OBSERVATION REPORT

Project: **Strata Plan LMS 280 – Chateau Comox** File No. S18-558
1272 Comox Street Report No. **1**
Vancouver, B.C. Date: May 08, 2019

ITEM: Building Envelope Field Review

Photos No. 1.1 and 1.2

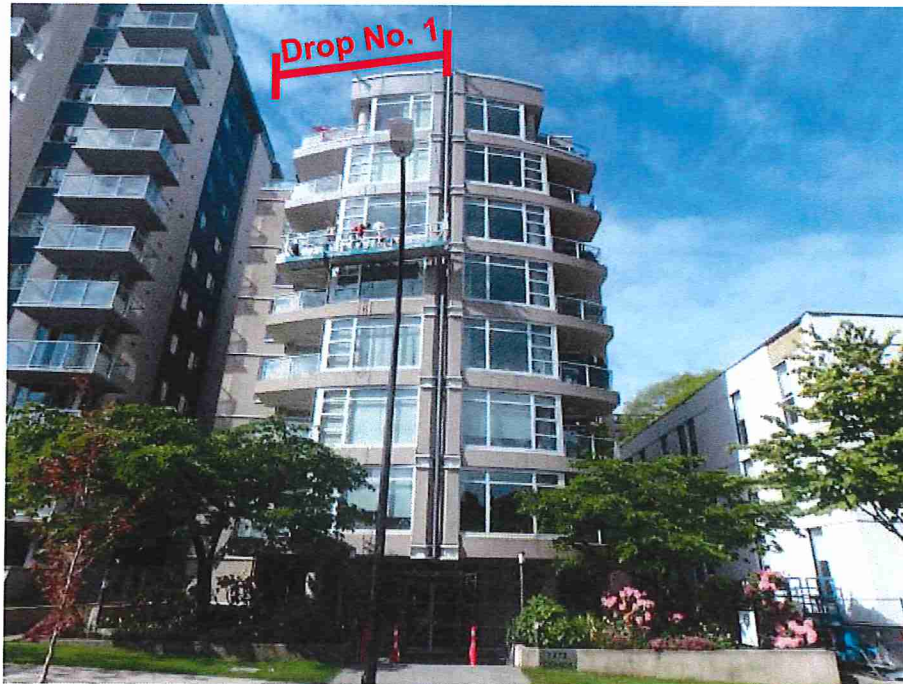
1.2	Spectrum Painting has begun work on the first drop of this project, Drop No. 1, located on the east half of the north elevation. At the time of review, pressure washing was complete and first coat paint application was underway on the stucco walls (Photo No. 1.1).

1.3	For field walls areas, the contractor is utilizing Dulux Diamond exterior latex paint. Balcony guardrails and other metal components will be painted with Devoe Devlac 1437 enamel. Strata Council has approved the colour match for both products. SEE will send under separate cover a record of the products and colour match formulas for the strata's records (Photos No. 1.2 and 1.3).

Photos No. 1.3 and 1.4

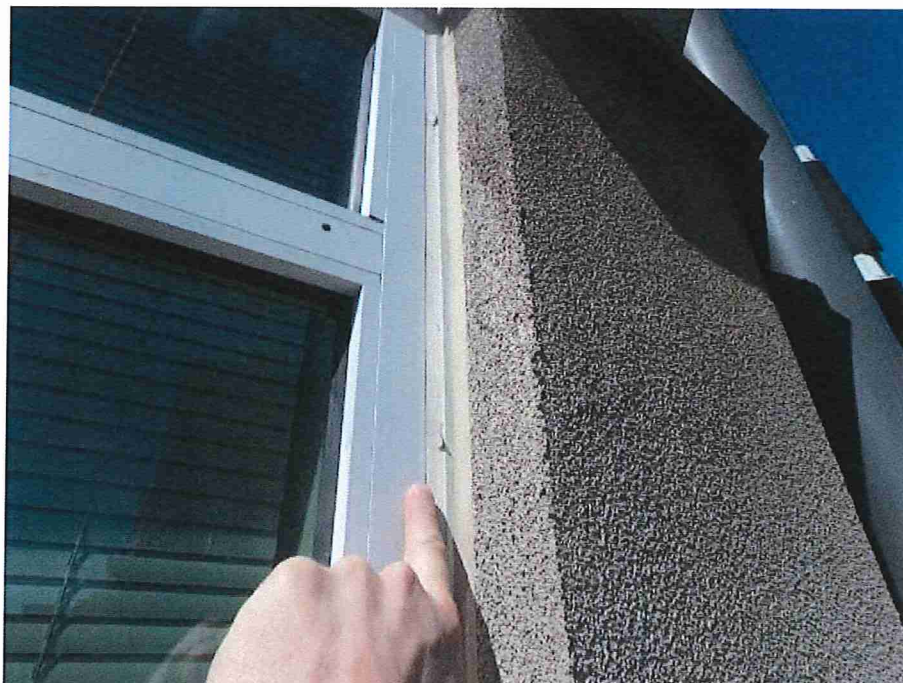
1.4	SEE reviewed the scope and extent of repainting. At window jambs, the paint application shall extend across both window perimeter sealant beads, terminating at the edge of the window frame. At the balcony soffits, the soffit shall be coated with flat sheen paint while the vertical surfaces and walls shall receive semi-gloss. The transition from flat to semi-gloss shall occur in the drip edge where available, or at the lowest edge of the 45° cant where no drip edge is cast into the concrete (Photos No. 1.4 to 1.6).

Photos No. 1.7 and 1.8

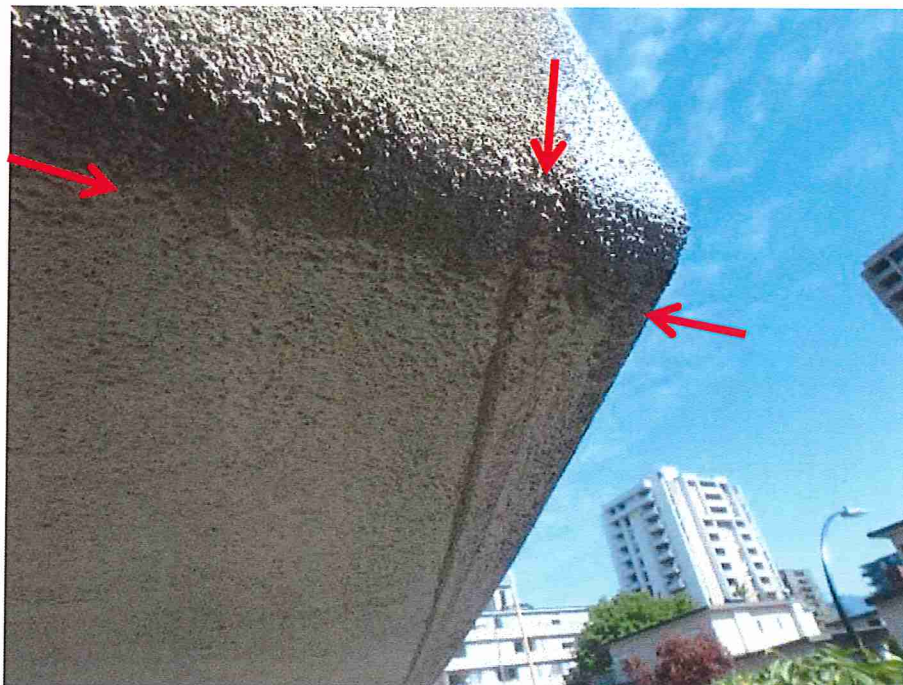
- 1.5 Drop No. 1, Level 8: Rusted steel and minor concrete spalls were uncovered along the concrete overhang and drip edge at the balcony. All loose concrete must be chipped away to expose 1" clear around the steel. The exposed steel shall be cleaned to a bright metal finish with a grinder then protected with a high zinc solid primer such as Galvacon. The concrete profile shall be reinstated with an overhead patching mortar such as Mapei Planitop and once secured, the acrylic stucco finish shall be reapplied (Photos No. 1.7 to 1.9). SP
-
- 1.6 In preparation for the next drop which has known areas of delaminated acrylic stucco finish, SEE has requested Spectrum Painting provide a sample board of the acrylic stucco repair material for texture approval by the Strata Council.
-
